Technical change to 9441700000

RS 16IO 2W R S 9441700000

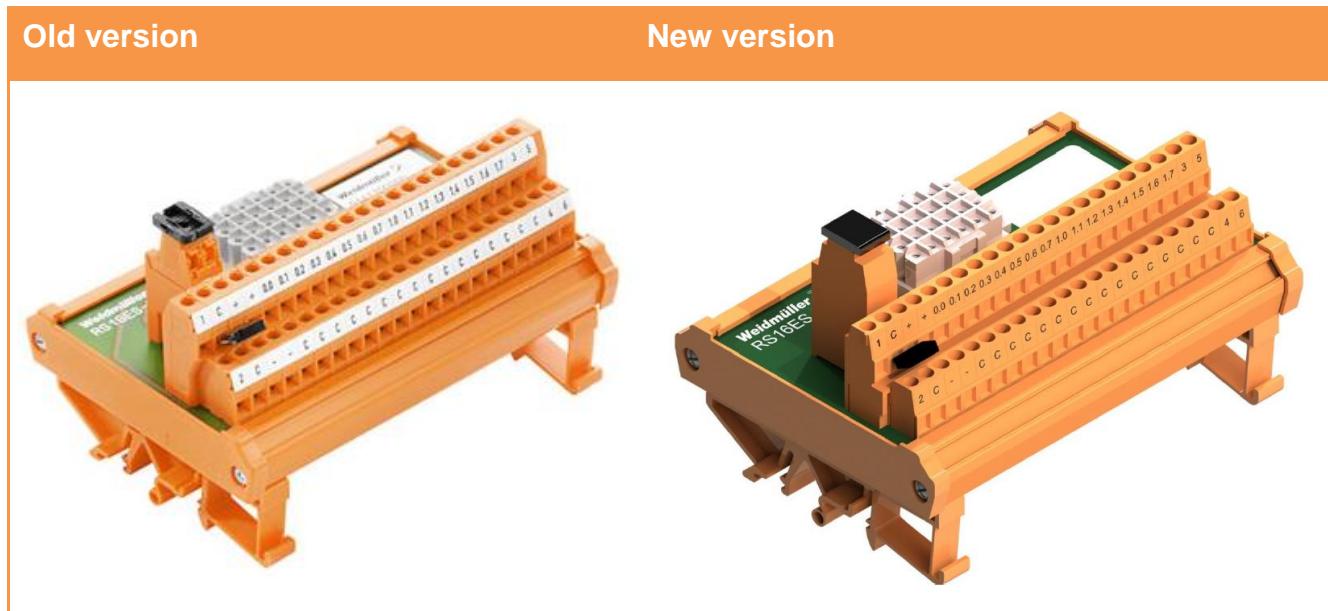
9441700000 had no UL approvals and were delivered with LPK connectors which will be obsolete very soon.

Based on continuous improvement, the LPK connectors + Dekafix used in 9441700000 will be replaced by LM connectors + pad printing technology.
Furthermore, module has been released according to UL recognized requirements.
UL ratings: 150V / 1A

Obsolescence of LPK connectors range and addition of UL recognized approvals to the product.

Since today new productions will be with new modifications detailed above (Compatibility indicator 1).
Availability from cw23/2020
